# CITY OF ALBUQUERQUE

**RE: Lot 1 Block 5 Unit 18, S.A.D. 227 Unser Cliffs Subdivision  
6524 Onyx Ct NW Grading and Drainage Plan  
Engineers Stamp Date: 10/26/18 (D10D053)  
Pad Certification Date: 12/11/18**

AS-BUILT SURVEY OF GRADED PAD

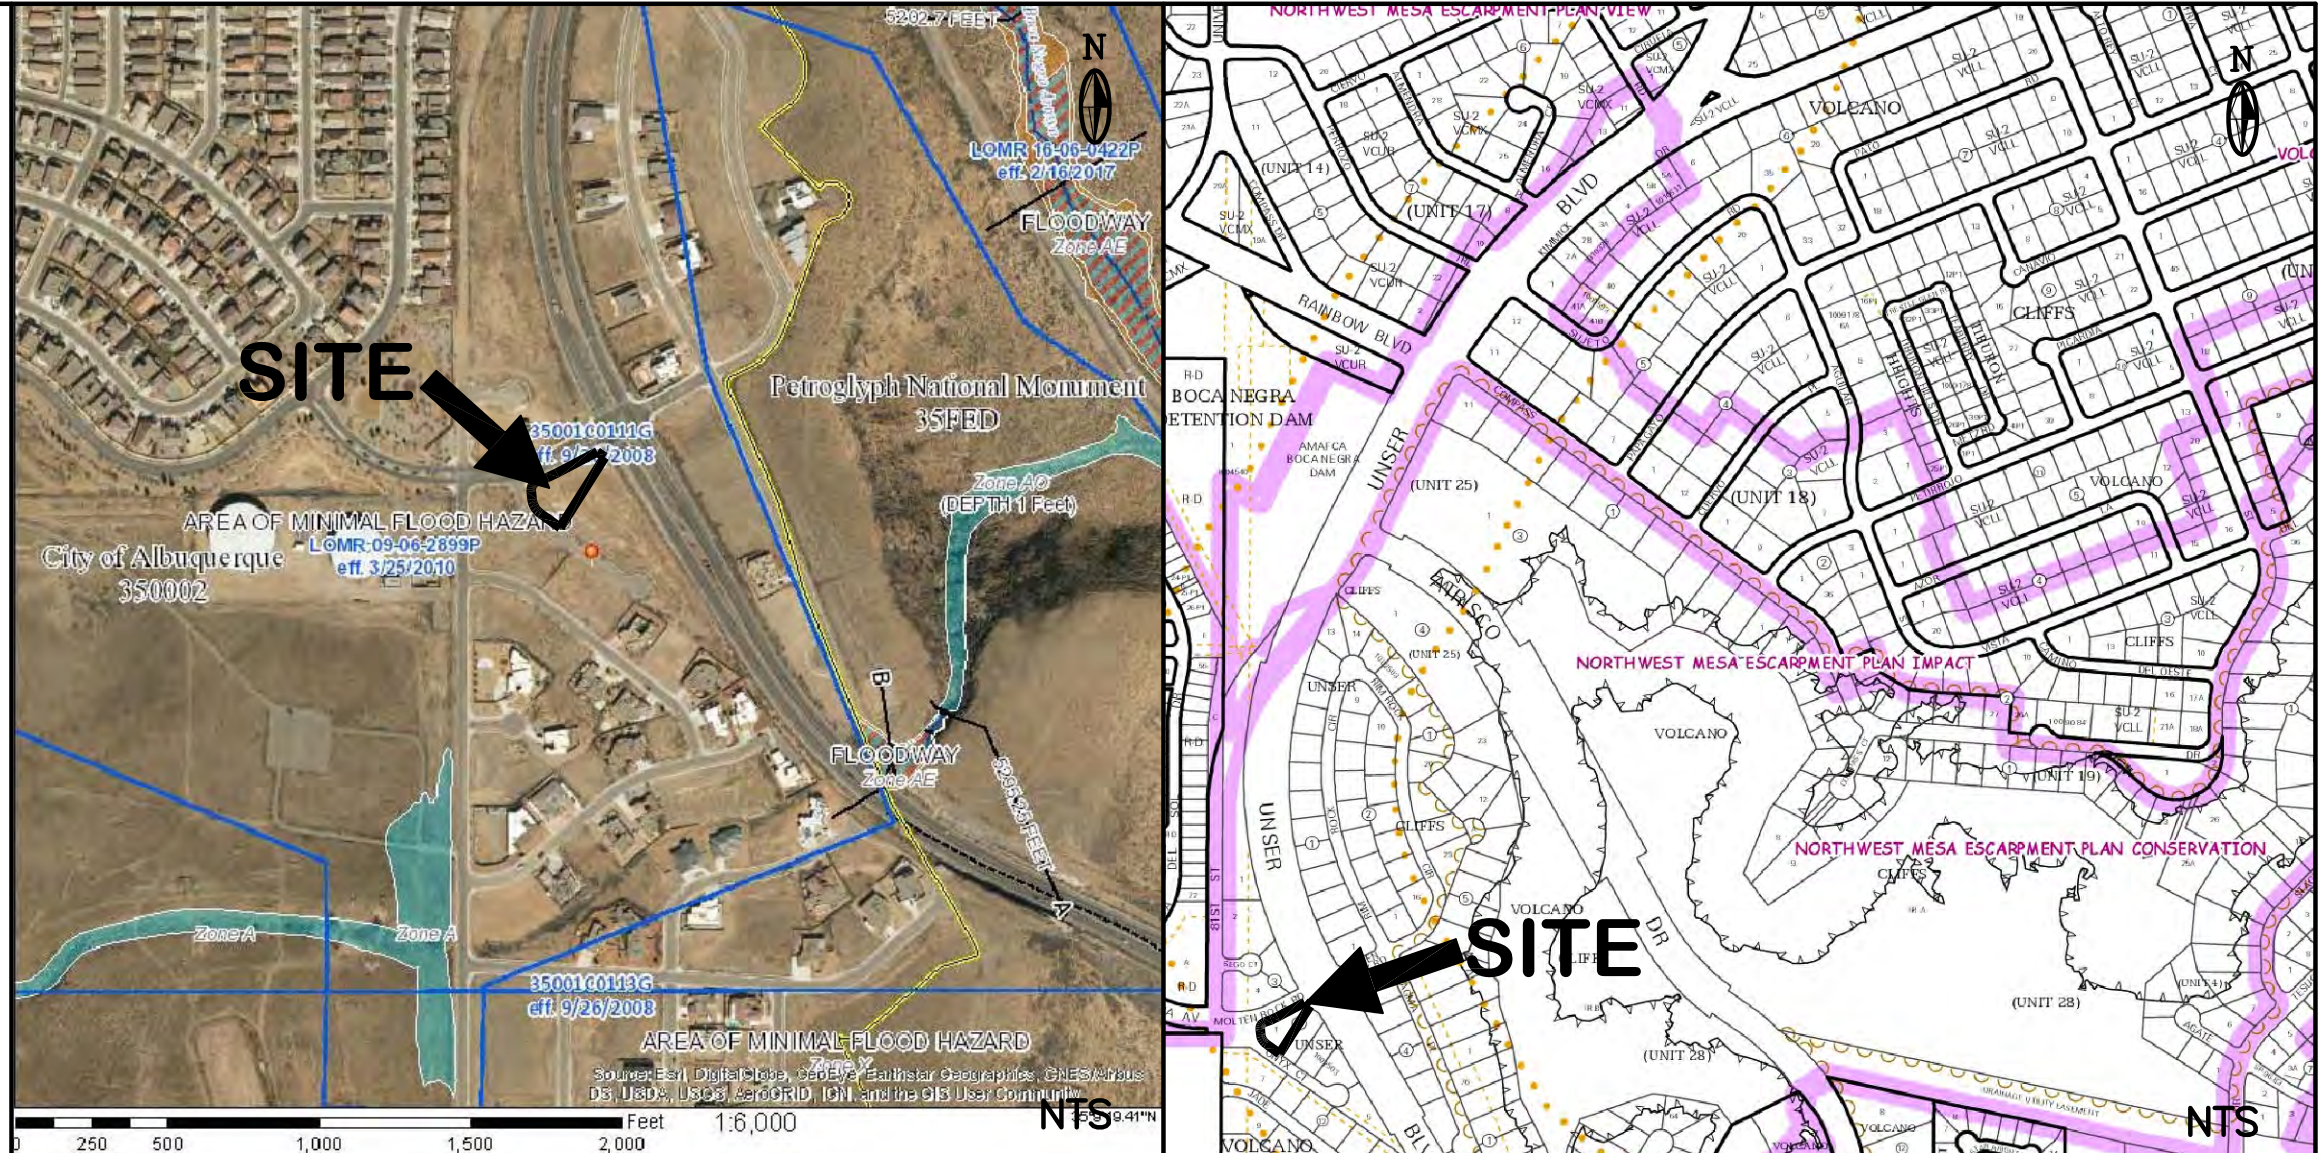
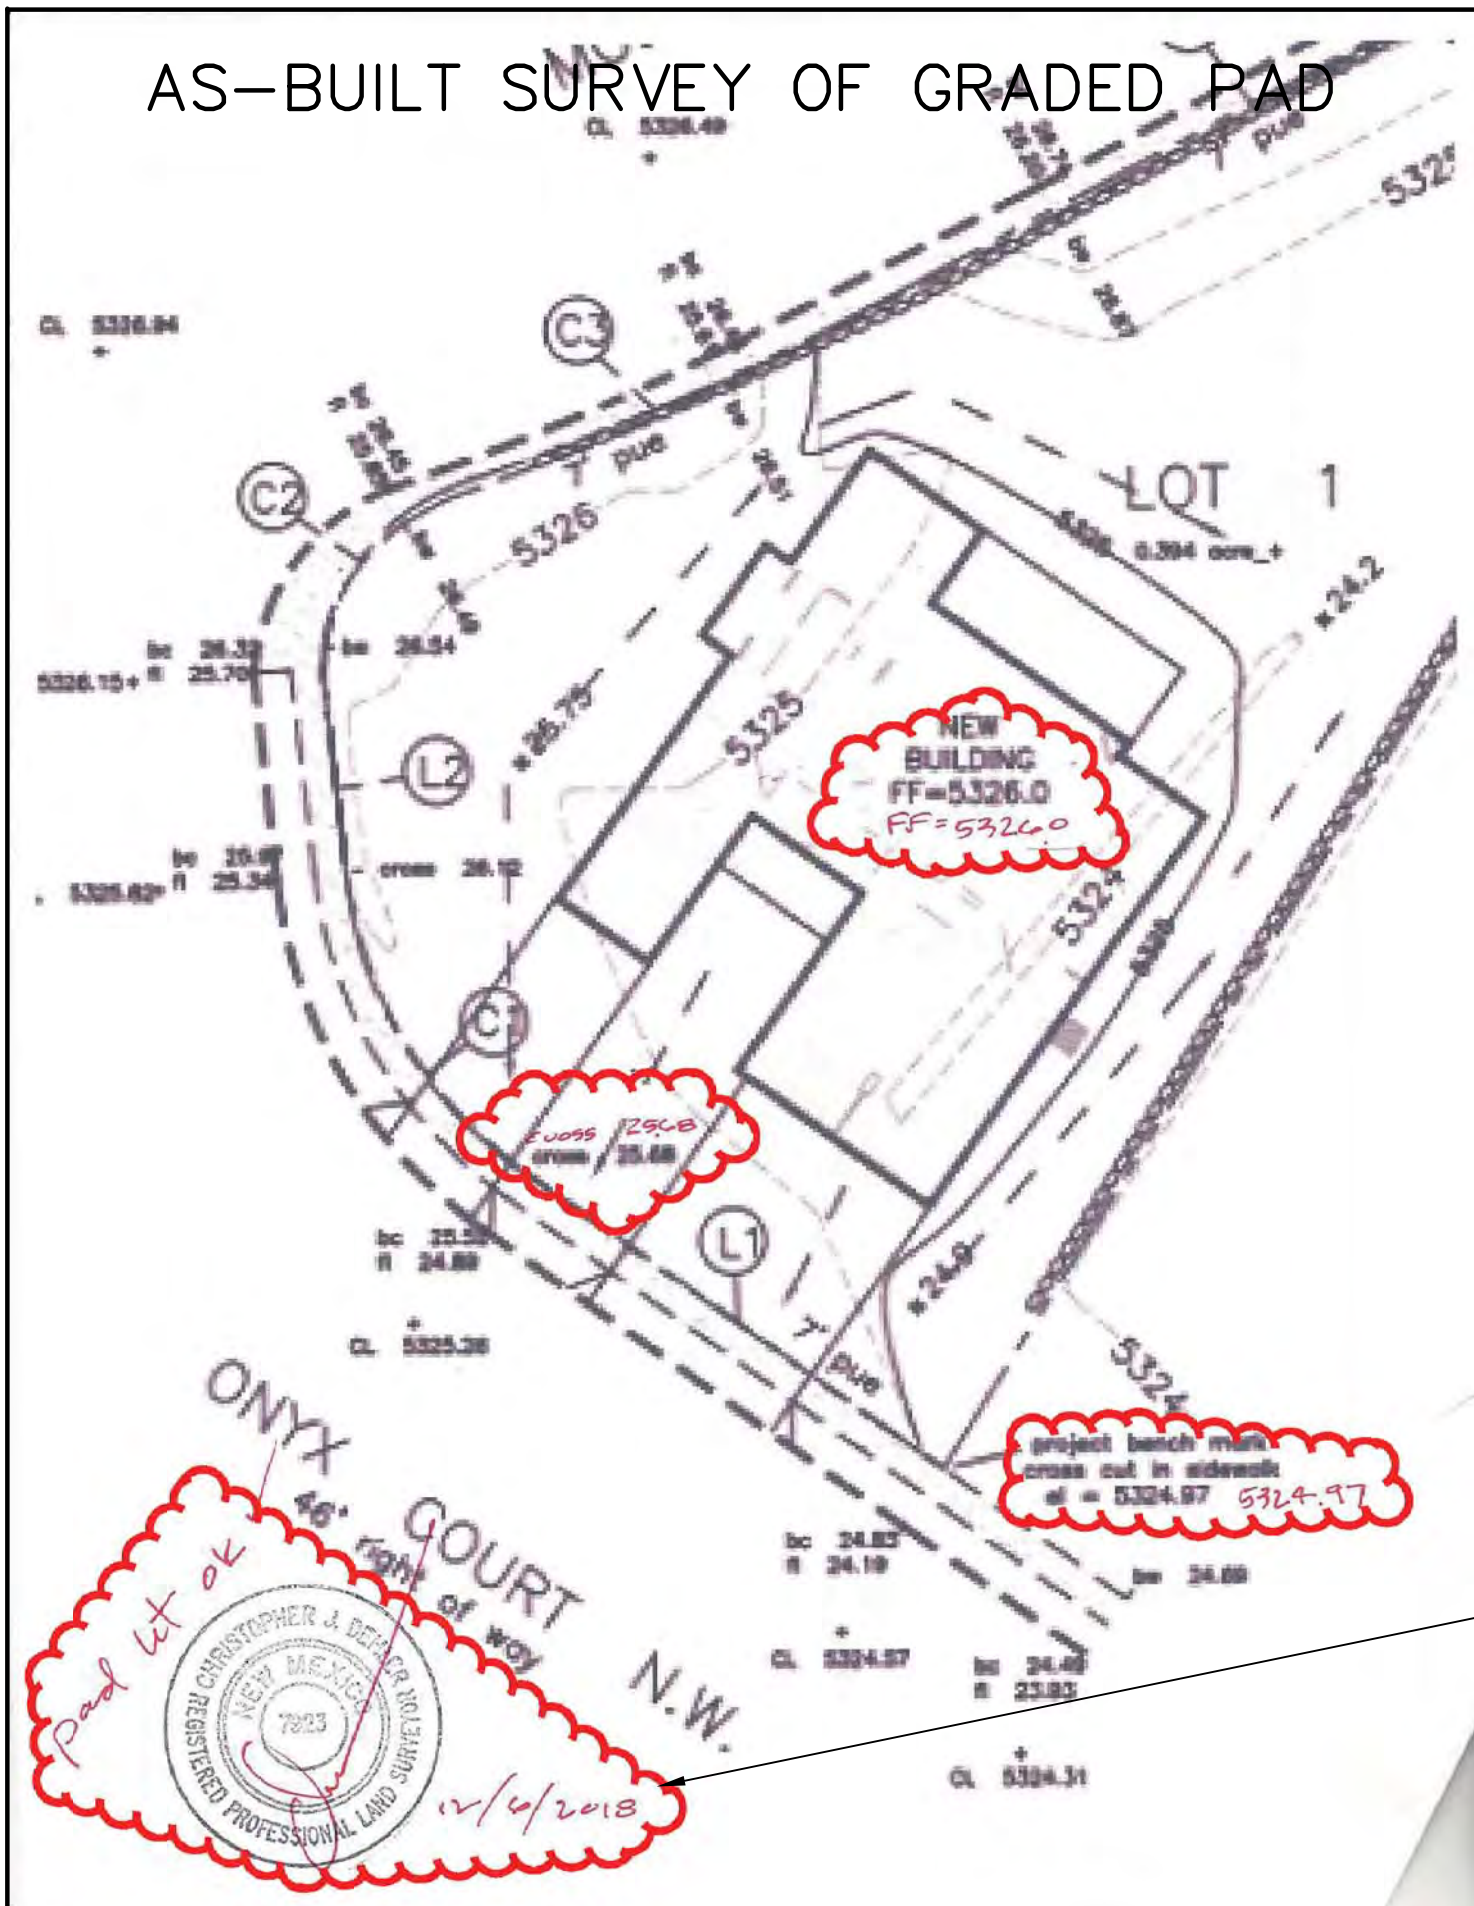
Based upon the information provided in your submittal received 12/12/18, this plan is approved for Building Permit.

Reiterate to the Owner/Contractor that a separate permit for any garden/retaining wall must be obtained, with the approved G&D plan dated 4/10/18.

Prior to Certificate of Occupancy release, Engineer Certification per the DPM checklist of this plan will be required. A fee of \$75.00 will be charged for this certification. If an additional resubmittal is required a \$75.00 fee for each resubmittal will be charged.
